Product Support Bulletin 2011-014

Maintenance of Way ~ Work Equipment Bulletin

SUBJECT: Brake Lever Replacement Kit 98310106

FIGURE 1. OLD STYLE LEVER
1/8" Gap between cylinder and frame weldment

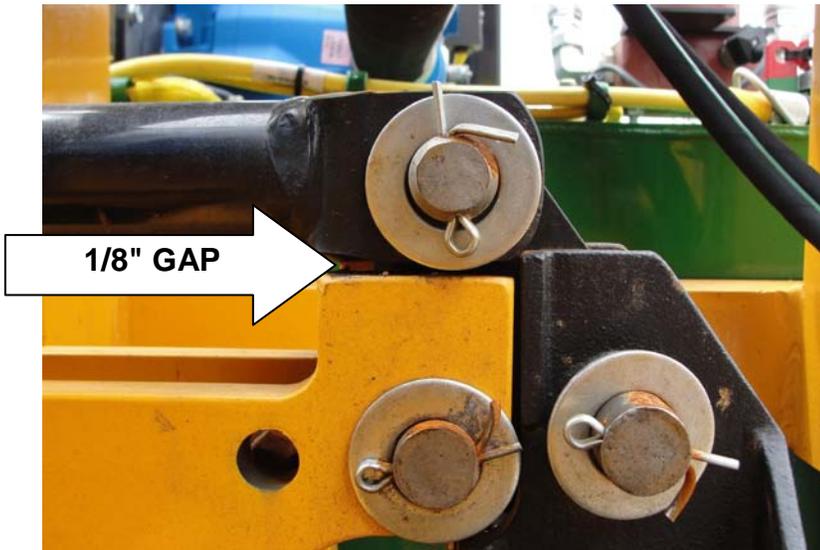
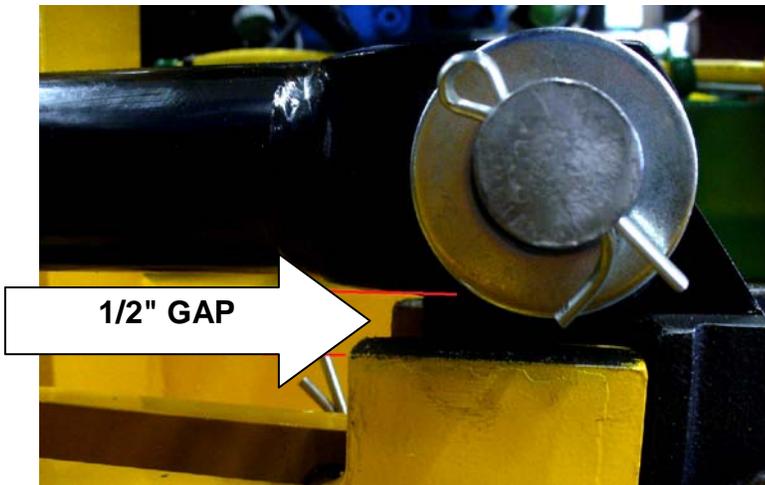
SUMMARY: A new brake lever has been designed that will allow full wear and longer life of the brake pads. The new brake lever has been made 3/8 inch longer between top and bottom hole. See next page for photos illustrating difference between old and new levers.

OPERATIONAL IMPACT: A redesign of the frame brake mounts that took effect on the machines listed above did not allow full wear of the brake pad, which resulted in premature replacement of the brake pad.

ACTION: Brake levers need to be replaced on all machines listed above. Caging of the brake cylinder is required for this installation. A Kit, Nordco P/N 98310106, has been developed that includes four brake levers, two spring compression rods used for caging the cylinder, 4 nuts, and installation instructions. One kit is required per machine.
